Access Compliance Report

Public Rights-of-Way

(Curb Ramps)

Intersection ID: 10029152	Main Street: JAVITZ_RD	Cross Street: N/A	Location: S
ADA ID: 56732081173F	Ramp Type: Perp	Initial Pass/Fail: Fail	Overall Compliance: No
Severity Score: 8.75			
Codes/Mitigation Info/Possible Solution		Field Measurements/Component Compliance

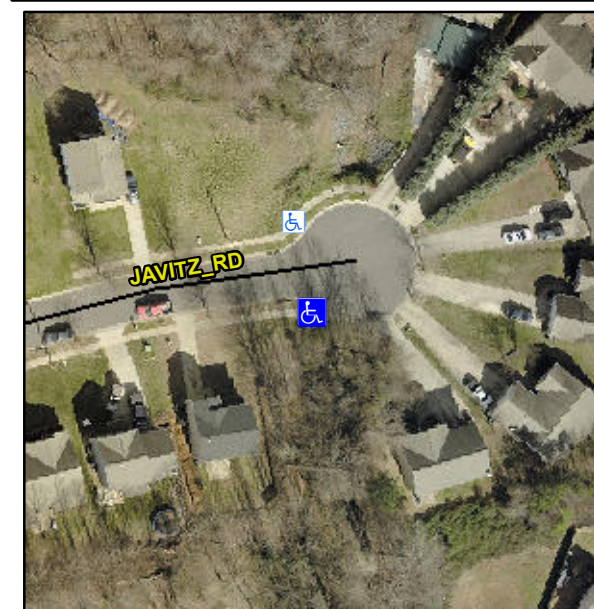
Not Found, R304.5.1

Compliance	Description	Data	Compliance	Description	Data
N/A	Ramp Length (in)	49.0	Yes	Ramp Slope (%)	5.6
No	Ramp Width (in)	46.5	Yes	Ramp XSlope (%)	1.2
N/A	Flare Type LT	N/A	N/A	Flare Type RT	N/A
N/A	Flare Slope LT (%)	N/A	N/A	Flare Slope RT (%)	N/A
N/A	Flare Traversable LT?	N/A	N/A	Flare Traversable RT?	N/A
N/A	Landing Length (in)	N/A	N/A	DWS Provided?	N/A
N/A	Landing Width (in)	N/A	N/A	DWS Contrast?	N/A
N/A	Landing Slope (%)	N/A	N/A	DWS Length (in)	N/A
N/A	Landing X Slope (%)	N/A	N/A	DWS Full Width?	N/A
N/A	Landing Curb? (Y/N)	N/A	N/A	DWS Offset (in)	N/A
N/A	Shared Landing?	N/A			
N/A	Gutter Ponding?	N/A	N/A	Gutter Slope (%)	N/A
N/A	Gutter Lip Ht (in)	N/A	N/A	Gutter X Slope (%)	N/A
N/A	Painted X Walk1?	No	N/A	Painted X Walk2?	N/A
	X Walk 1 Direction	To N		X Walk 2 Direction	N/A
N/A	X Walk 1 Width (in)	N/A	N/A	X Walk 2 Width (in)	N/A
	X Walk 1 Slope (%)	3.3		X Walk 2 Slope (%)	N/A
	X Walk 1 X Slope (%)	1.3		X Walk 2 X Slope (%)	N/A

N/A	Ramp inside XWalk1?	N/A	N/A	Ramp inside XWalk2?	N/A
	Road Slope (%)	N/A	N/A	Clear Space?	N/A
	Road X Slope (%)	N/A	N/A	Clear Space to XWalk (in)	N/A
N/A	Any Obstructions?	N/A	N/A	Storm Grate/Utility Hazard?	N/A
	Obstruction Type			Storm Grate/Utility Type	
		N/A			N/A
			Yes	Surface Condition? (G/P)	Good

Remove & Replace Entire Ramp.
